NOVI-TEN PRO JZ23-09

NOVI-TEN PRO JZ23-09 WITH REZONING 18.740

PLANNING REVIEW
January 24, 2024

sheet number:
P.3

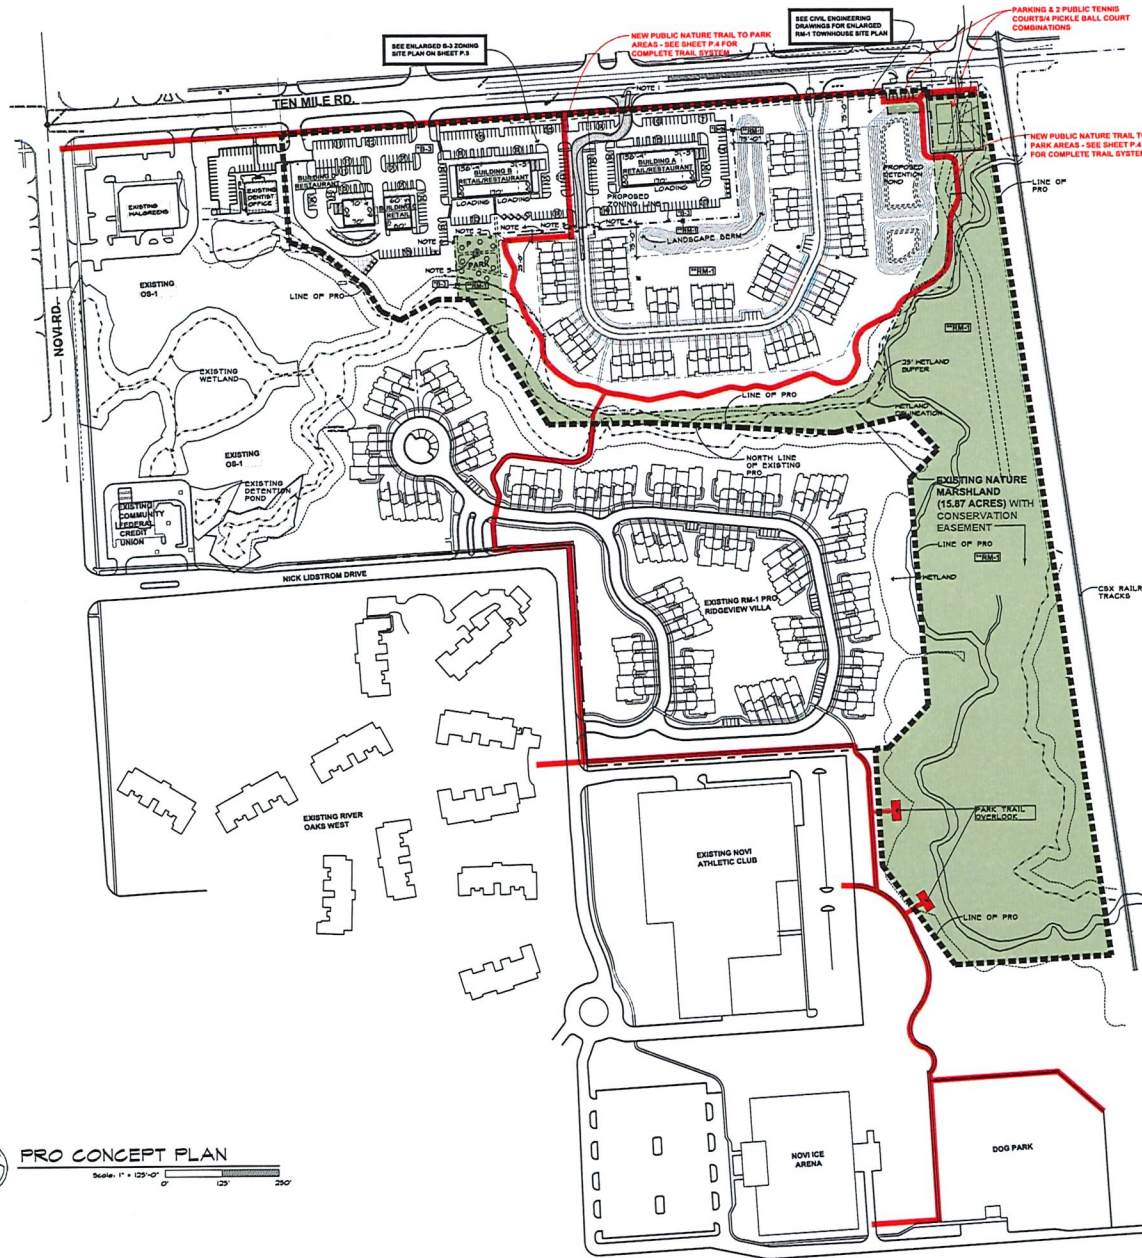
The size of the RM-1 area is 27.07 acres for the townhome parcel. To calculate density, the net site area of a site should exclude any wetlands greater than 2 acres, and right of way. Sheet 6 (revised) shows the total area of Wetland D is 10.729 acres. The net site area of the RM-1 development parcel as calculated by the applicant is 15.74 acres (excludes all 11.33 acres of wetlands on the site). As a result the density proposed is 4.5 dwelling units per acre (71 units/15.74 acres), which is within the ordinance standard.

The land is currently vacant. Development under the current OS-1 and I-1 zoning could result in a substantial amount of Office, Warehouse, or Research & Development buildings being constructed. On sheet P.2 of the Concept Plan provided, the applicant shows a 54,000 square foot office building on the OS-1 portion, and 291,200 square foot industrial building. However, this plan does

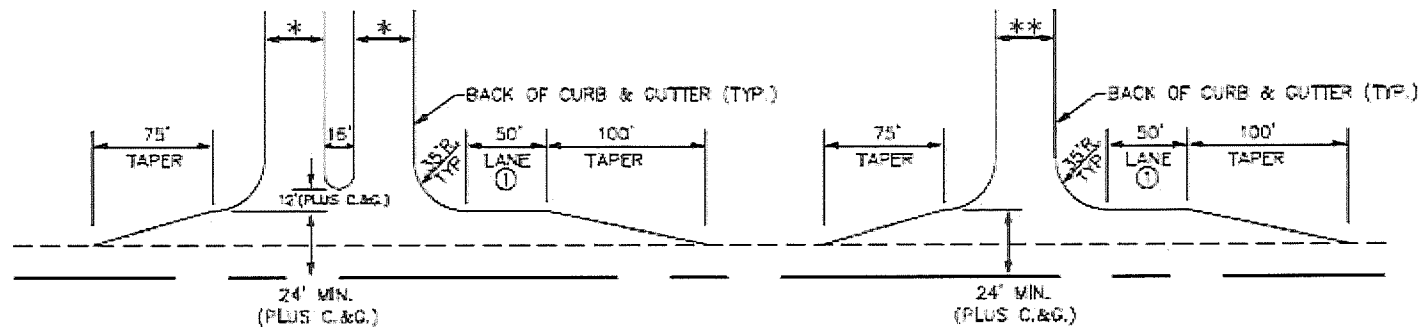
Carry 5-Lane cross section to just past double driveway.

WB Lane begins just east of that 2nd driveway with the driveway radius 35', 50' lane, and 100' taper.

Center Left Turn Lane (CLTL) extends past that driveway further with radius (35') + 50 lane + 550' taper (calculated by width (12*45) and speed = 540' rounded to 550'.)
